## **ADDENDUM NO. 2**

February 25, 2013

RE:           **Kitchen Improvements at Newark High School**  
75 East Delaware Avenue, Newark, Delaware 19711  
for  
**Christina School District**  
700 North Lombard Street, Wilmington, Delaware 19801  
EIA Project No. PP7279

EIA DRAWING NO.  
**ESK-1**

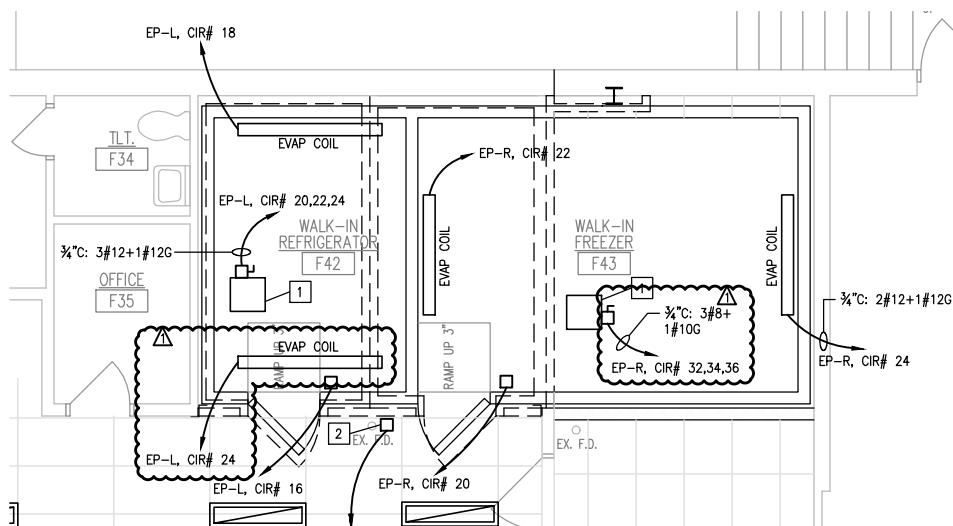
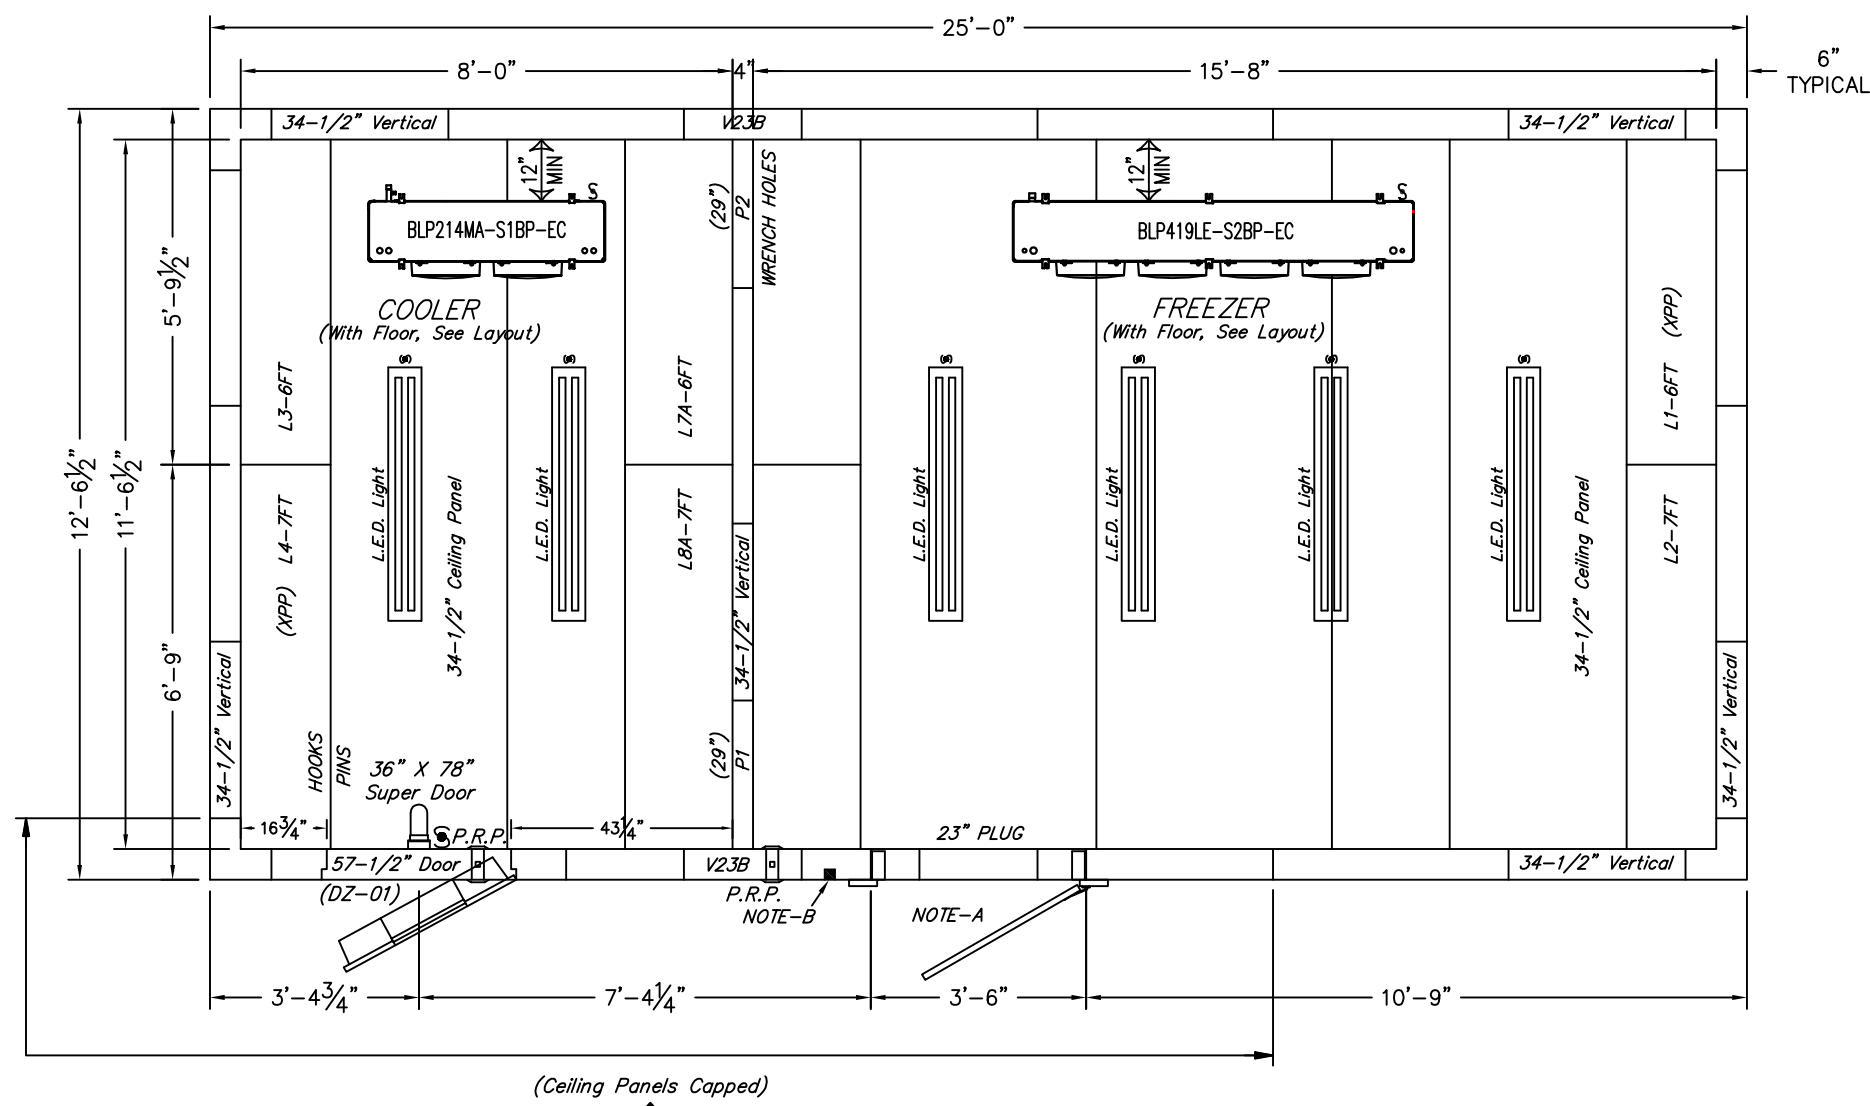
- 2.16 Drawing E1: Revise Partial Floor Plan and Existing Power Panel Schedules as shown by clouded marks on supplemental Drawing ESK-1, copy of which accompanies this addendum.

PROJECT NO. PP7279  
EIA DRAWING NO. FS-16

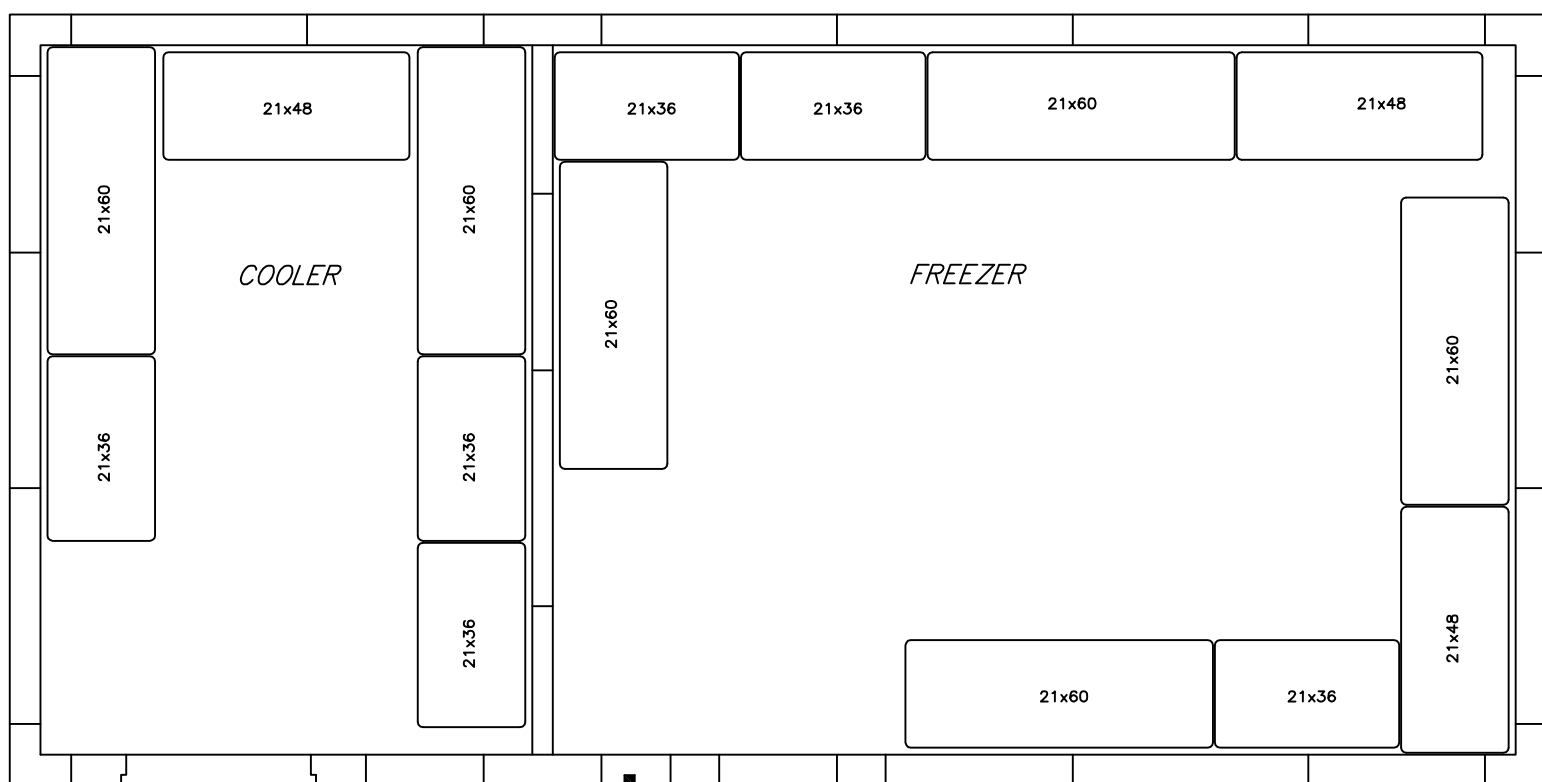
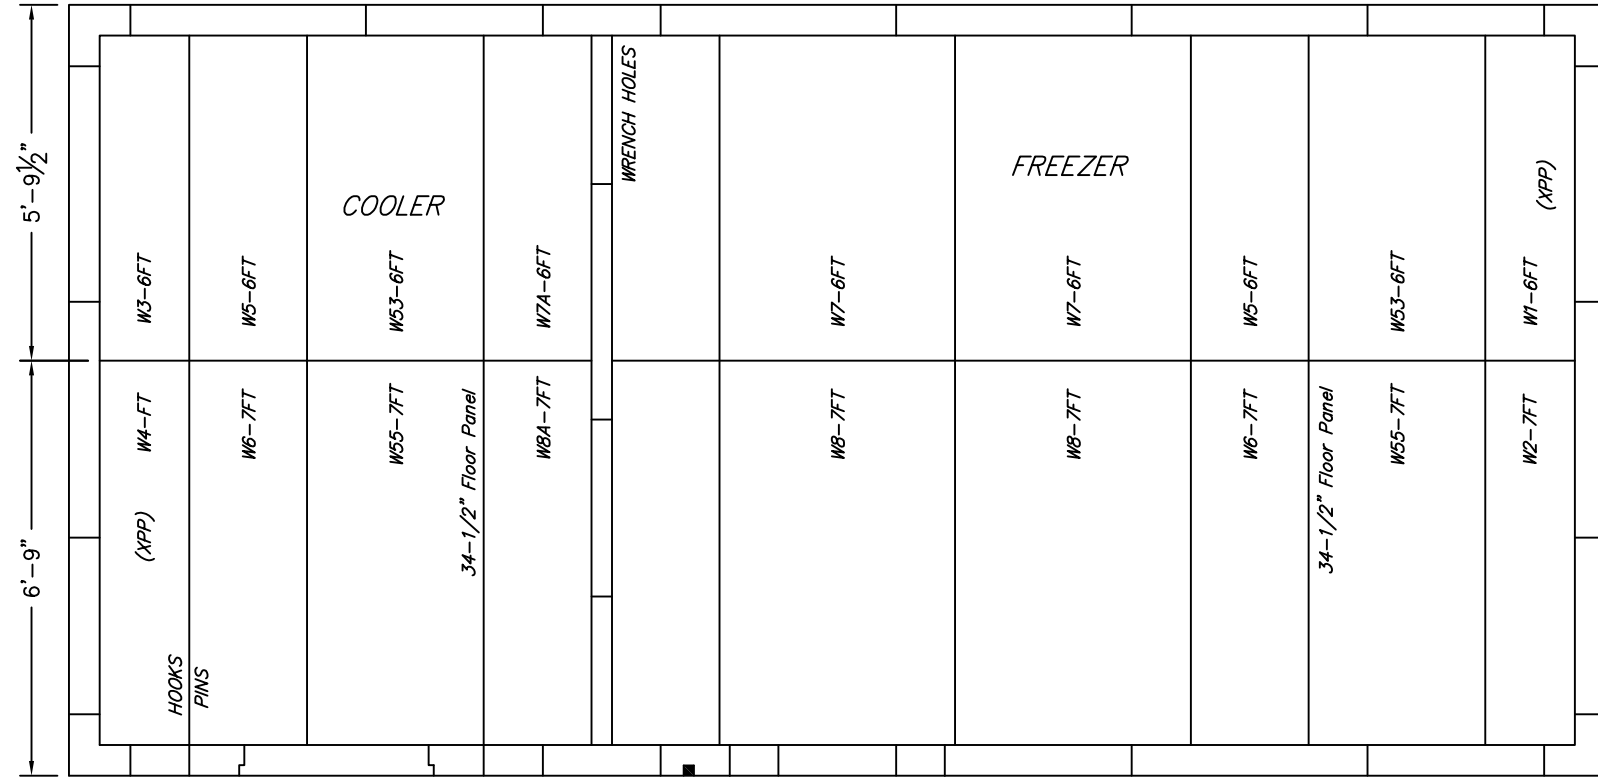
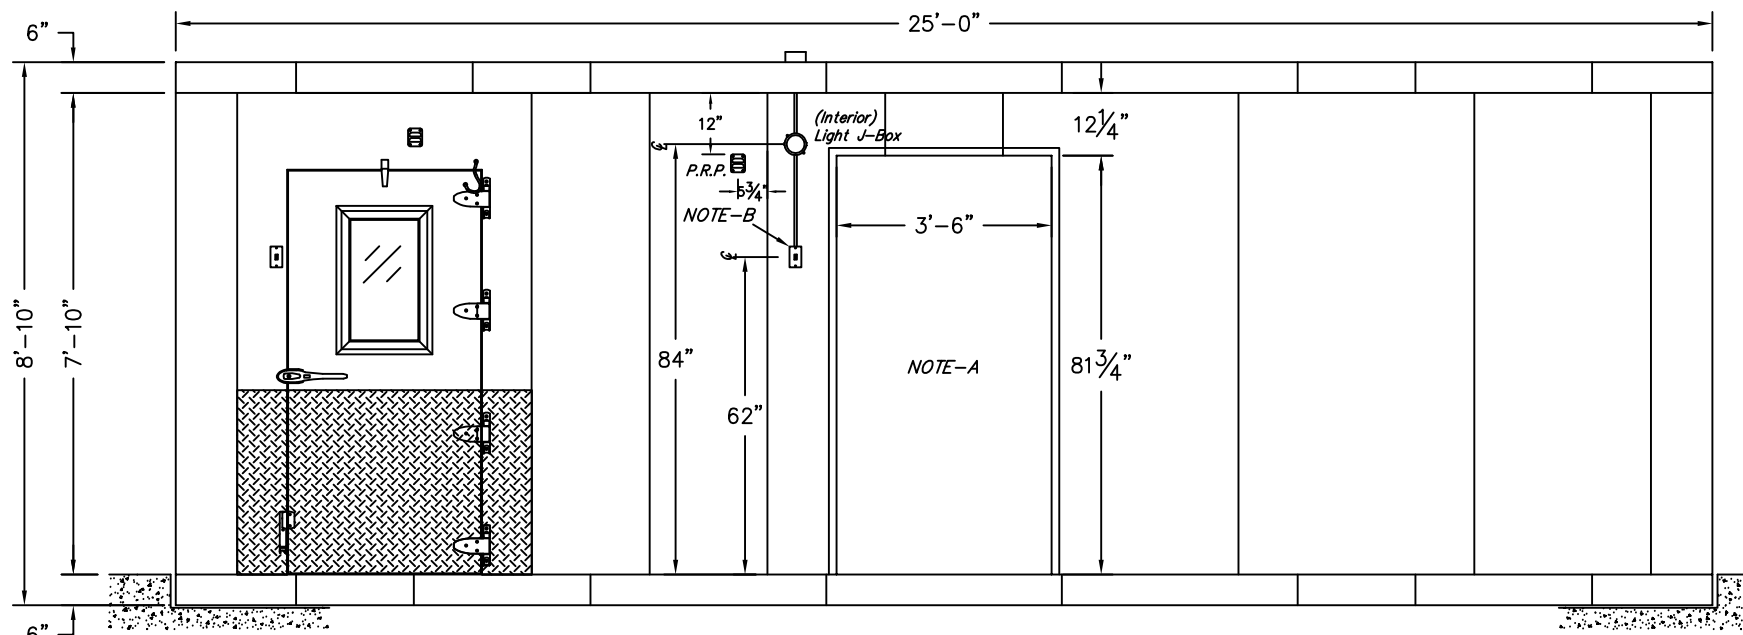
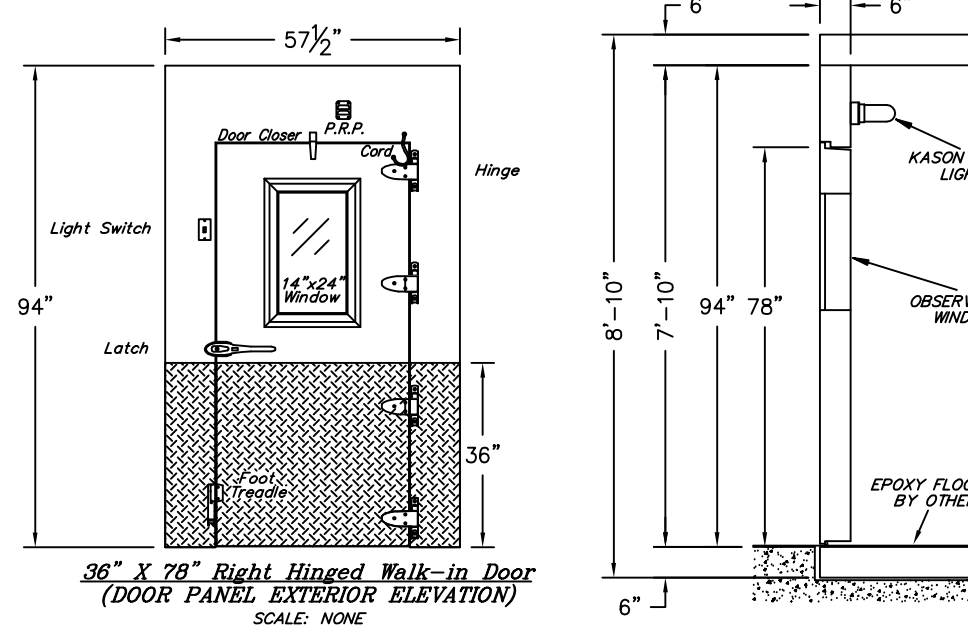
- 2.9 Drawing FS-1.6: Delete Drawing as originally included in bid set and replace with revised Drawing FS-1.6, copy of which accompanies this addendum. On the "Section Thru Entrance Door" on this new drawing, delete note referring to "Epoxy Flooring by Others."
